NRC LICENSE TRANSFER APPLICATION

Nine Mile Point Unit Nos. 1 & 2

NRC Facility Operating License Nos. DPR-63 and NPF-69

Re: Nine Mile Point Unit Nos. 1 & 2
Docket Nos. 50-220 & 50-410
Facility Operating License Nos. DPR-63 & NPF-69
Application for License Transfers and
Conforming Administrative License Amendments
TAC Nos. MB0878 (Unit 1) and MB0879 (Unit 2)

BASES FOR 3.2.6 AND 4.2.6 INSERVICE INSPECTION AND TESTING

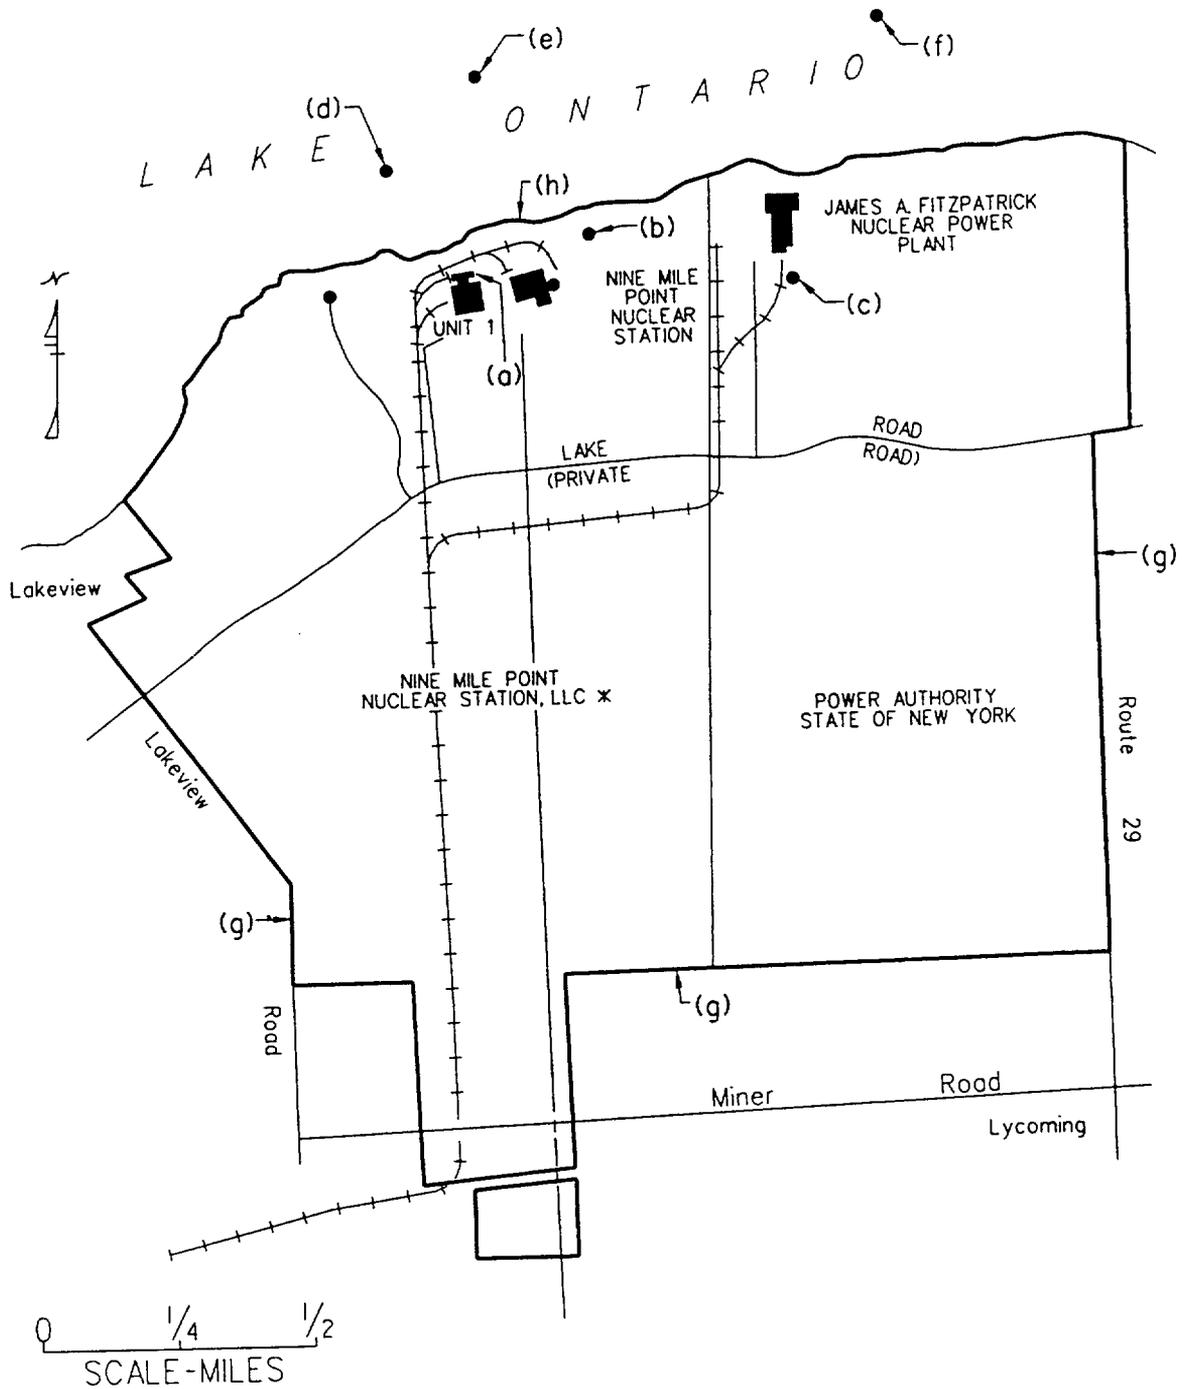
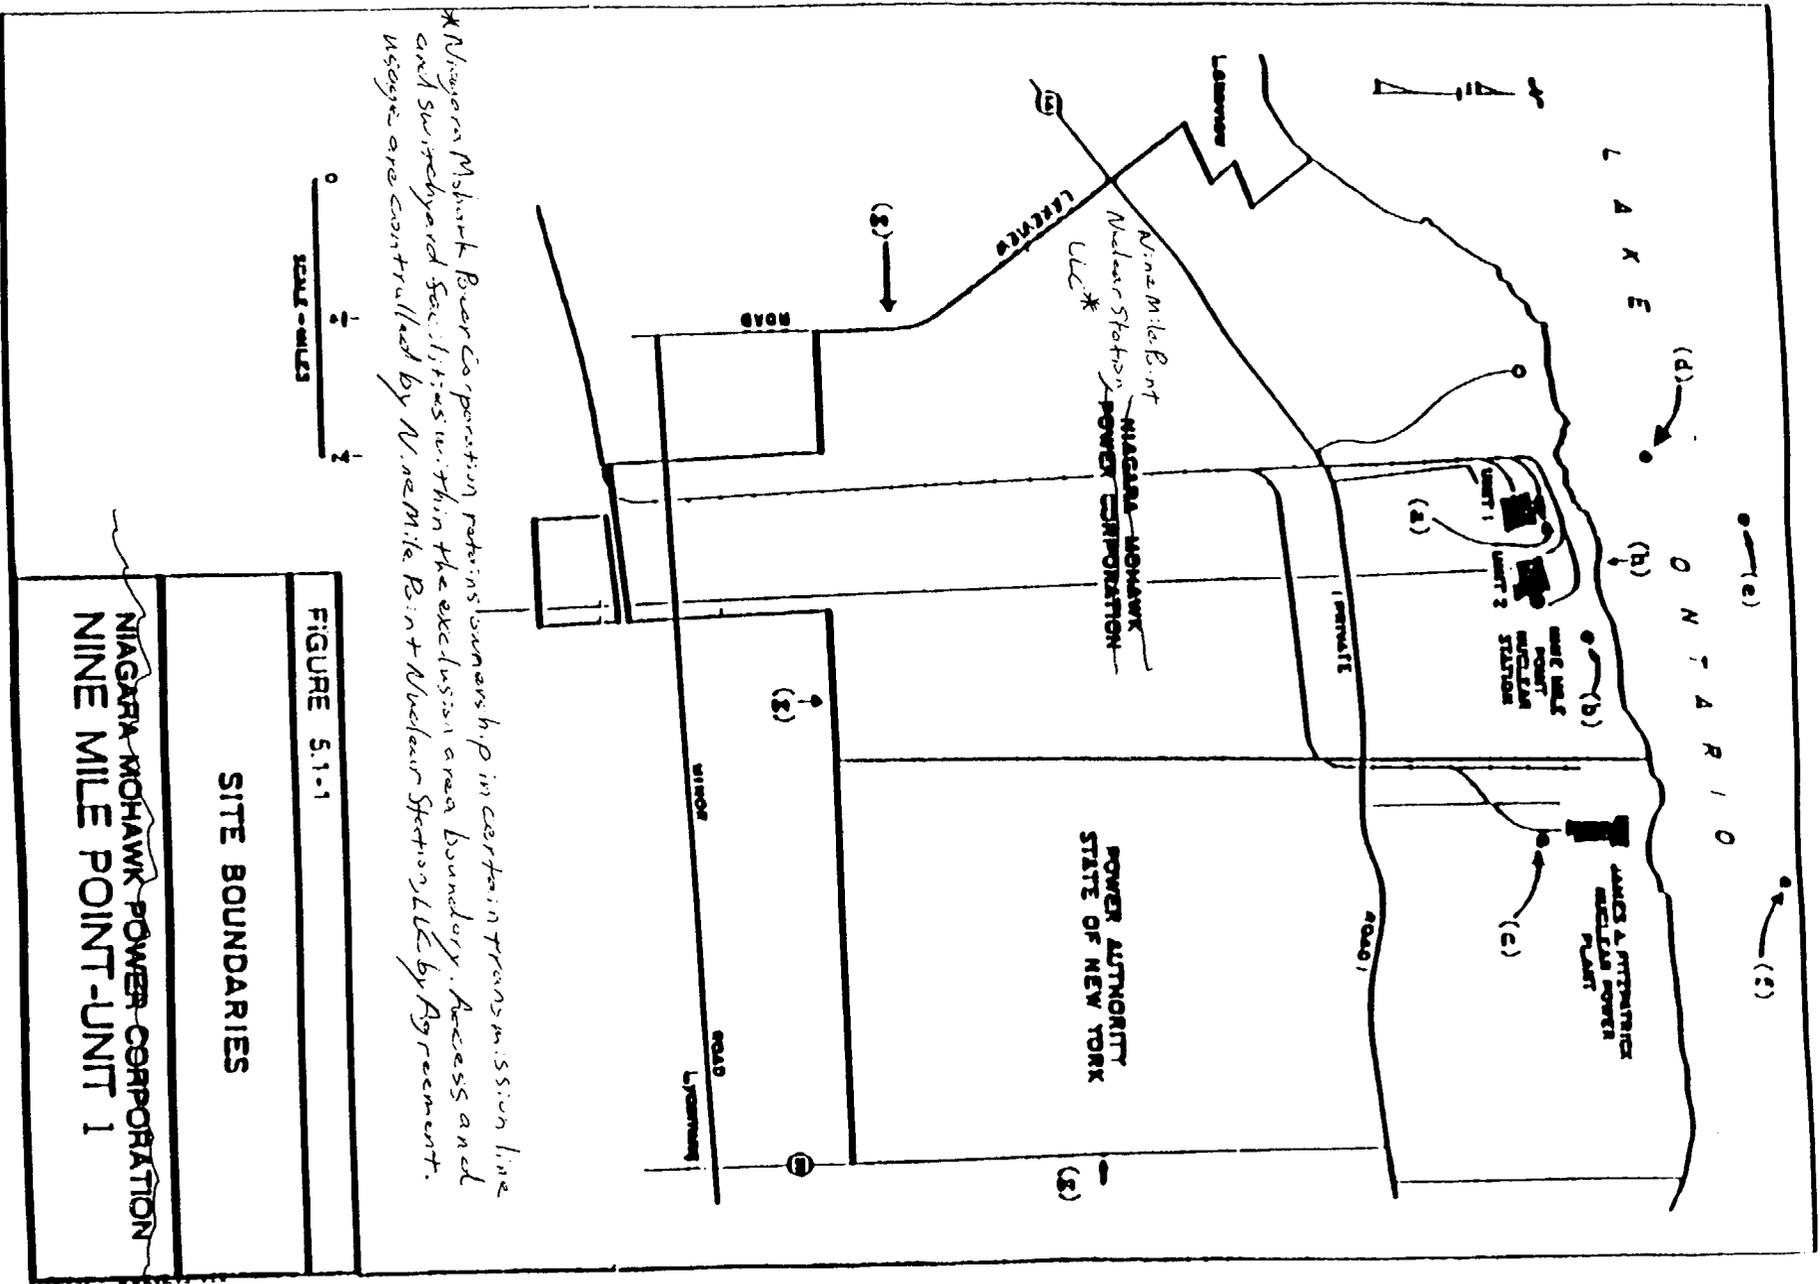
Page 107 Bases 3.2.6 and 4.2.6 - replace "Niagara Mohawk" with "the licensee" to reflect the change in owner and operator.
